REGULAR MEETING OF THE PLANNING BOARD WEDNESDAY, FEBRUARY 28, 2018 7:30 PM CITY COMMISSION ROOM 151 MARTIN STREET, BIRMINGHAM

- F. Final Site Plan & Design Review
 - 1. **525** Southfield (Former Wellness Center) Final Site Plan and Design Review of request to demolish existing building and replace with 8 unit attached single family residences.

- 34965 Woodward (Former Peabody Restaurant & Frame Shop) Request for approval of a Final Site Plan & Design to allow for construction of a new five story mixed use building.

- 3. **670 S. Old Woodward (Detroit Trading Company)** Final Site Plan and Design Review of request to replace existing entrance door with a garage door and sidelight and add a small 23 sq. ft. addition.

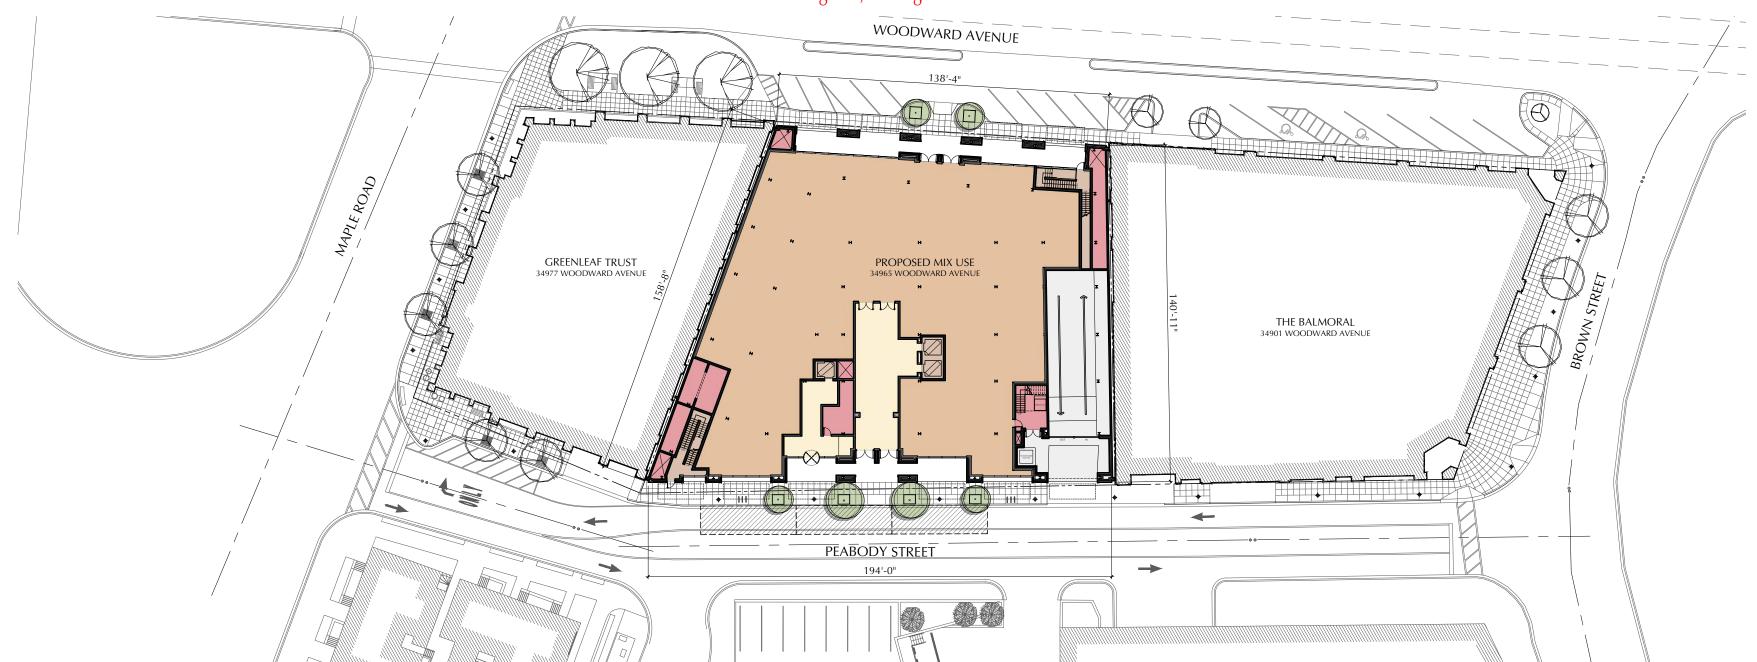
Opening Width:	Required: Proposed:	Maximum 25 ft. opening in façade for vehicles 20 ft.
Parking:	Required:	1.5 spaces per residential unit (10 units x 1.5 Spaces = 15 spaces required)
	Proposed:	88 spaces in underground structure, plus 11 public spaces in ROW on Woodward
Min. Parking Space Size:	Required:	180 ft ²
	Proposed:	180 ft ²
Parking in Frontage:	Required:	N/A
	Proposed:	N/A
Loading Area:	Required: Proposed:	3 off-street loading spaces (40 ft. x 12 ft.) None

Thus, the applicant will be required to provide the required loading spaces or obtain a variance from the Board of Zoning Appeals.
